**DOCUMENT 00 90 00  
ADDENDUM**

**ADDENDUM NO. [1]                      Date: March 13, 2020**

**RE:                      SCHOOL DISTRICT OF HOLMEN  
                             HIGH SCHOOL ADDITION AND REMODELING PHASE 2  
                             1001 McHUGH ROAD  
                             HOLMEN, WISCONSIN 54636  
                             HSR 18061**

**A090**

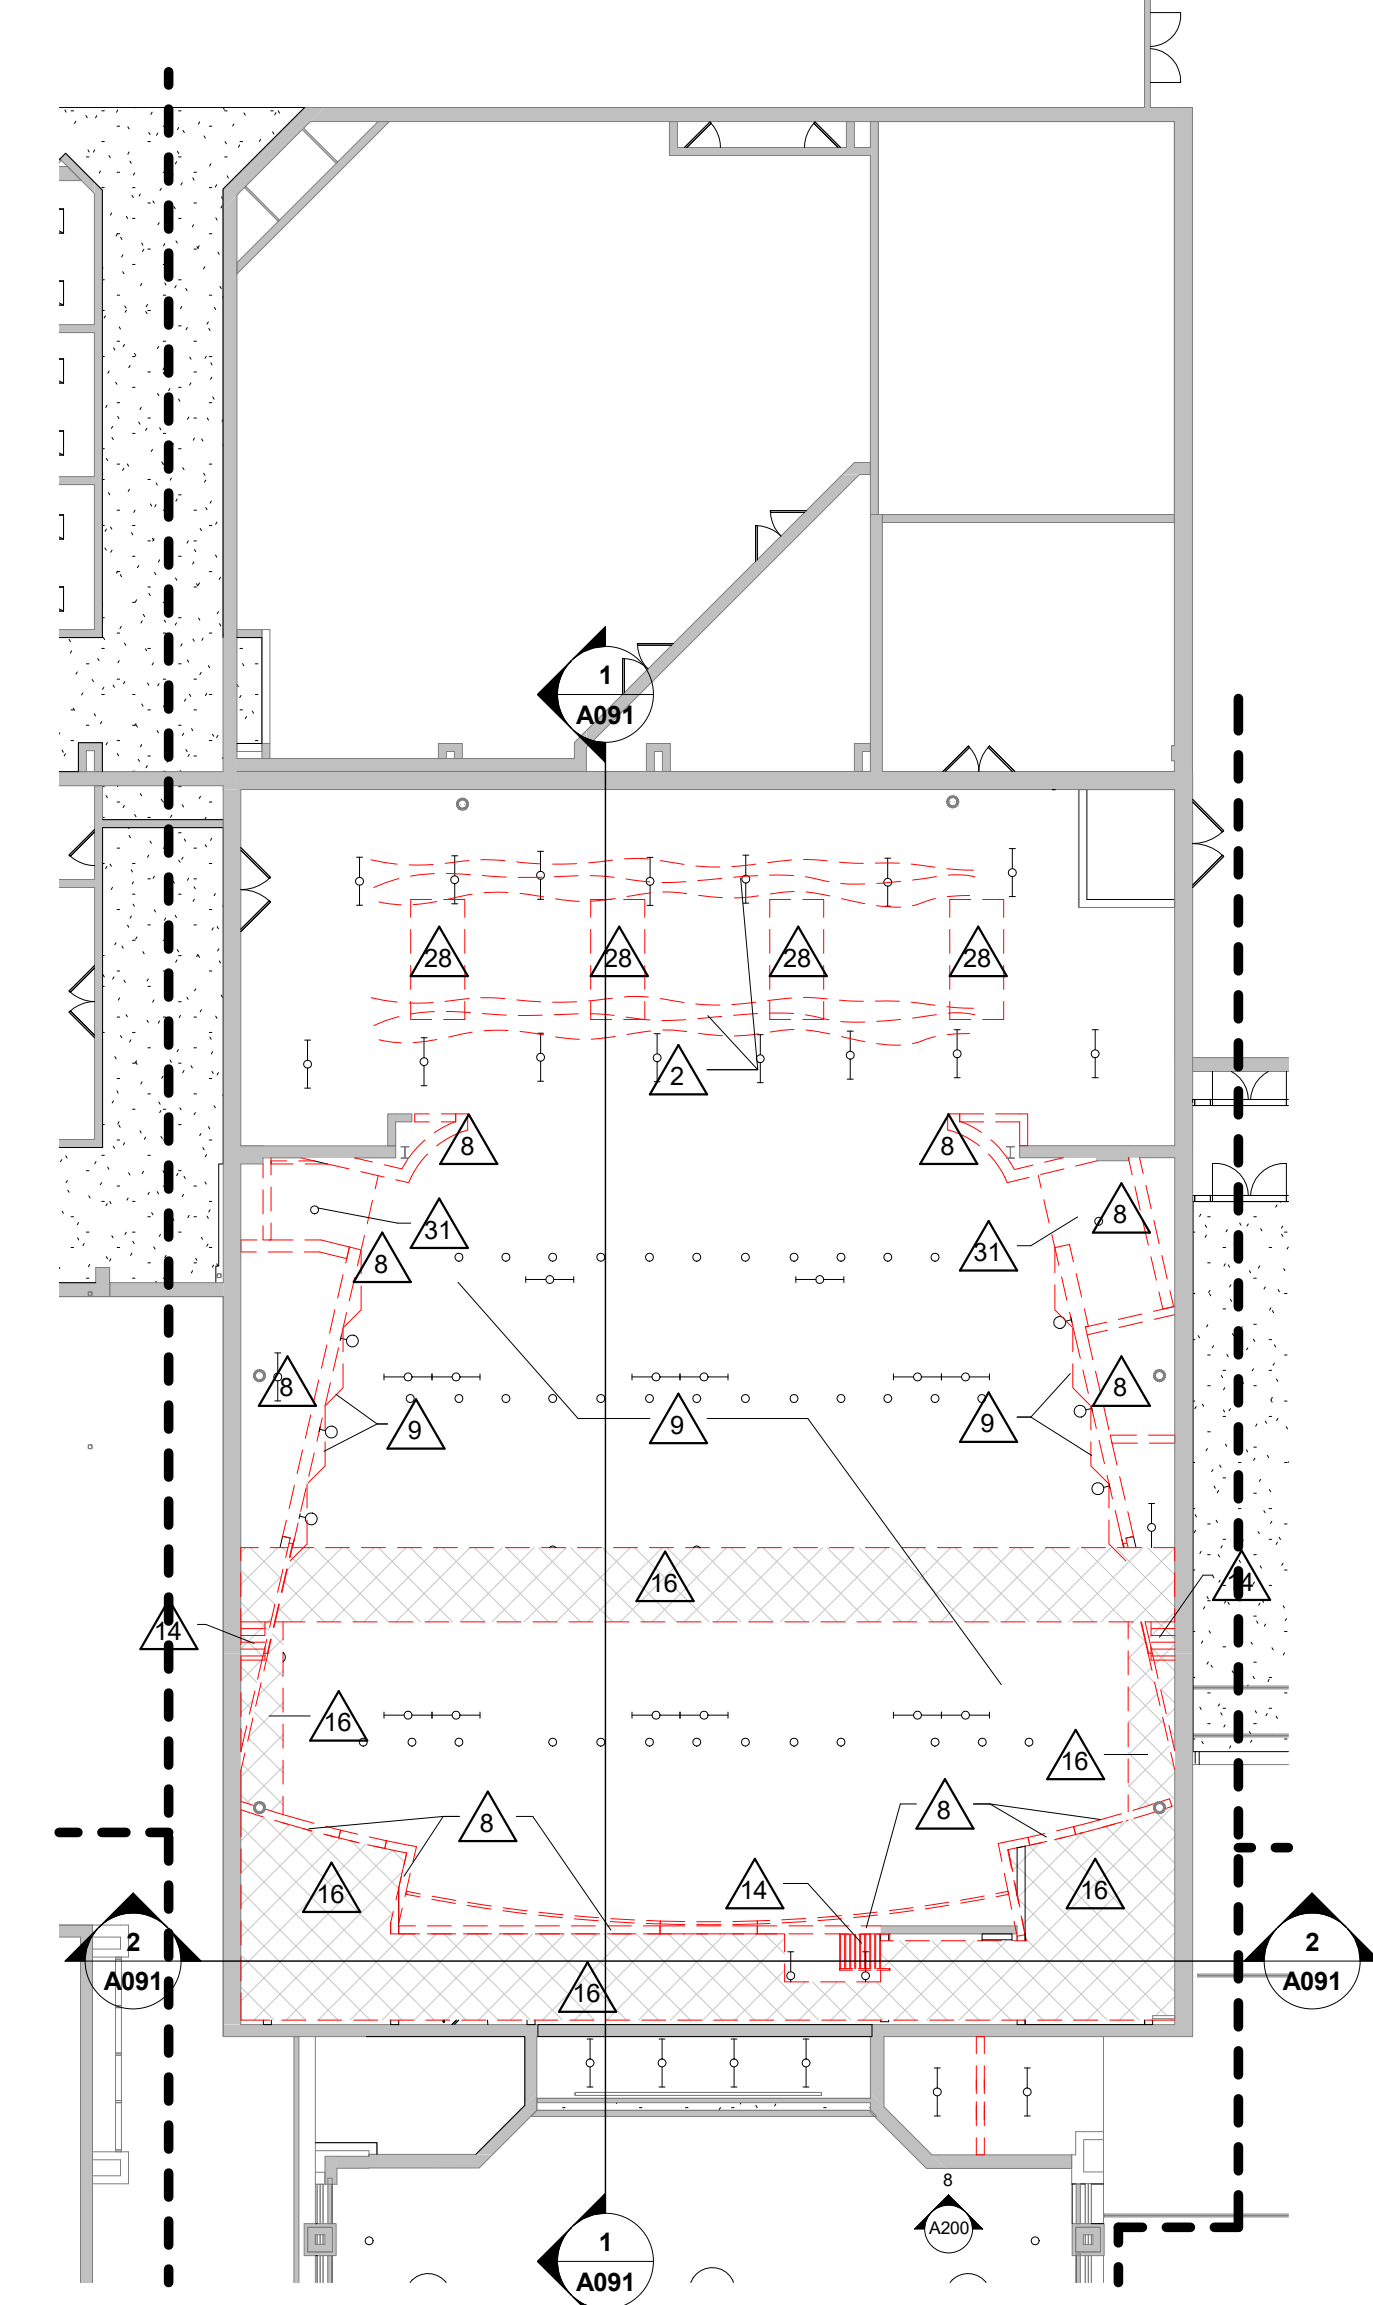
- a. Revisions clouded on Drawing.
- b. Slab removal indicated in Kitchen.
- c. Opening height indicated at SE corner of FAC.

**A123**

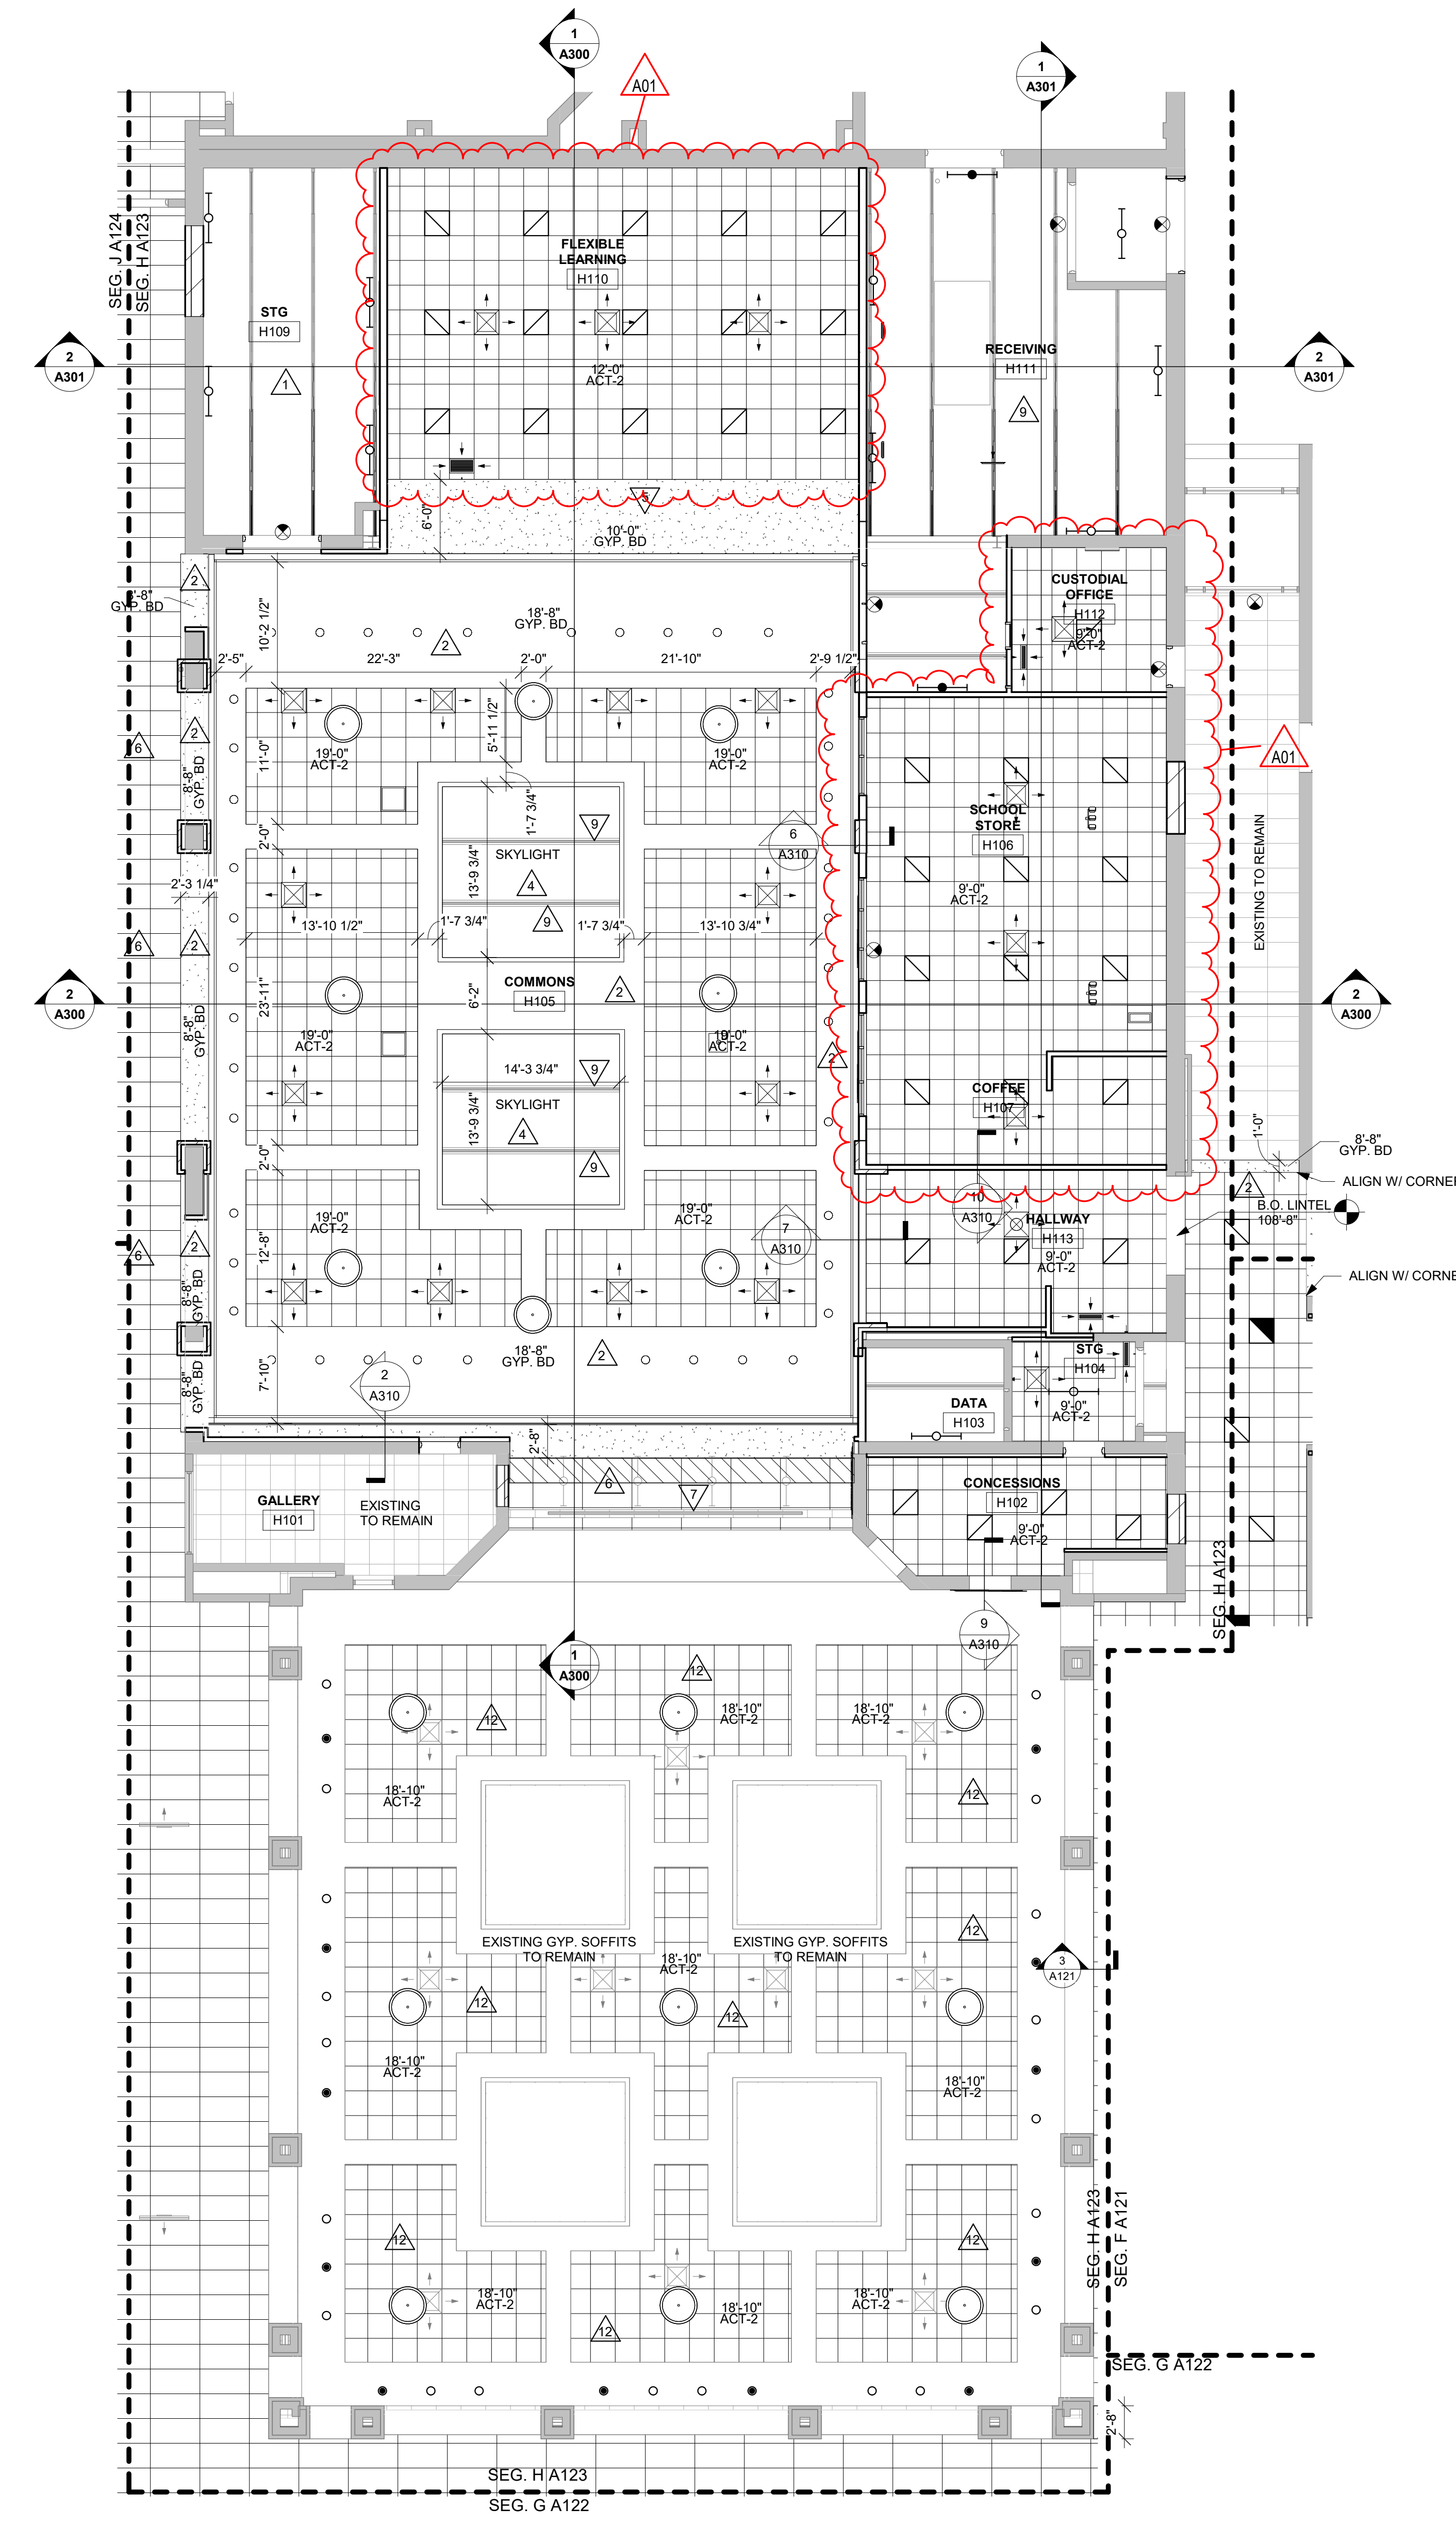
- a. Revisions clouded on Drawing.
- b. Rooms H106 and H110; deleted load requirements for secondary ceiling support. Ceiling shall be supported from existing structure above.

**2 COMMONS H105 EAST**  
1/4" = 1'-0"

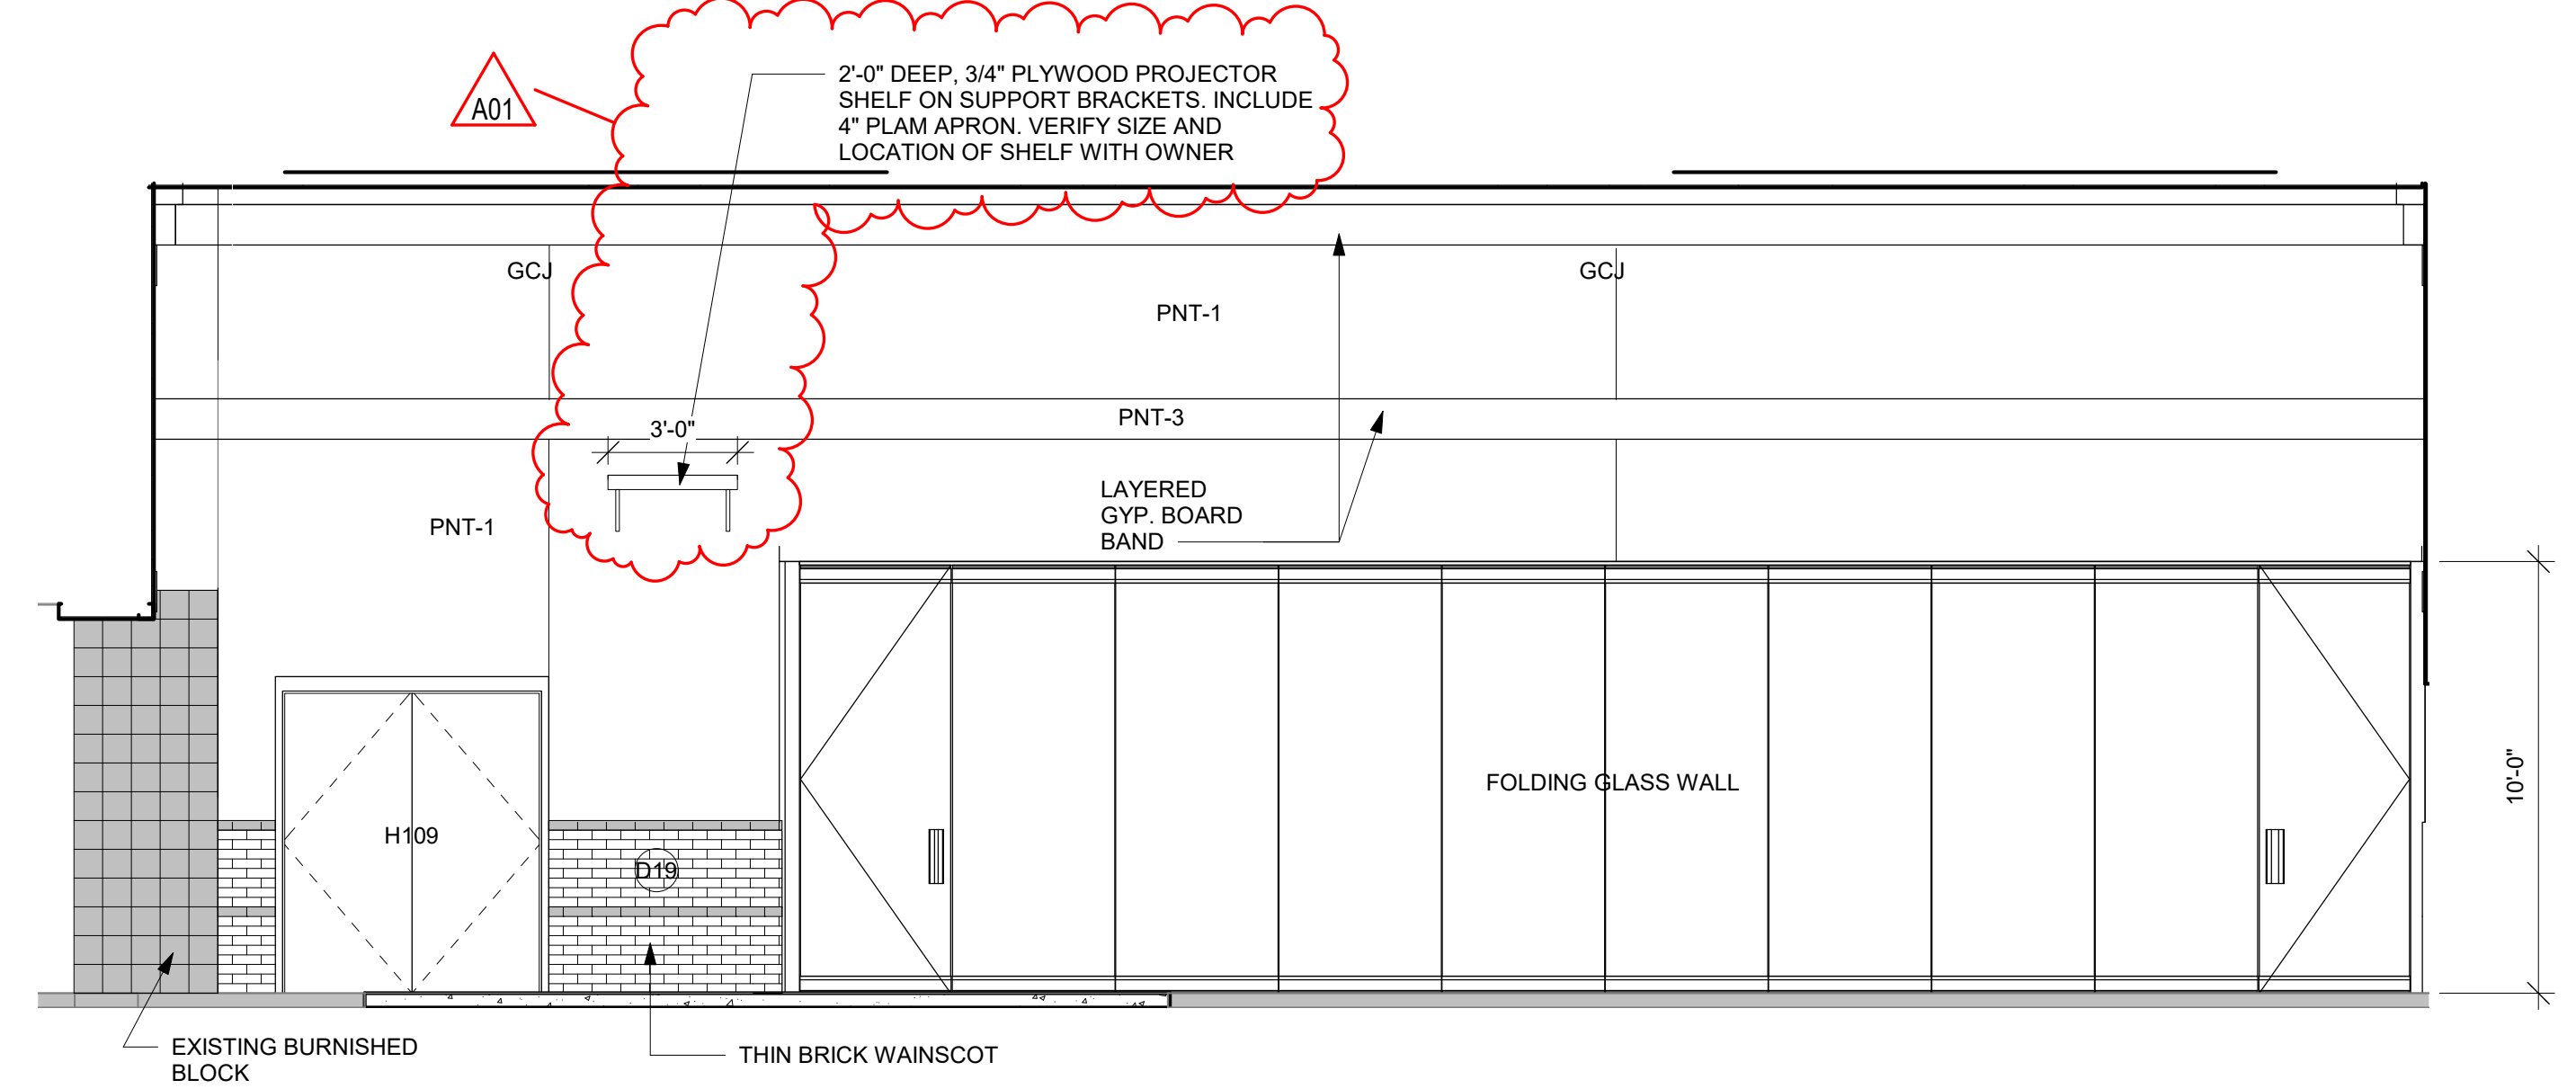
- a. Revisions clouded on Drawing.
- b. 2A200; Add projector shelf.
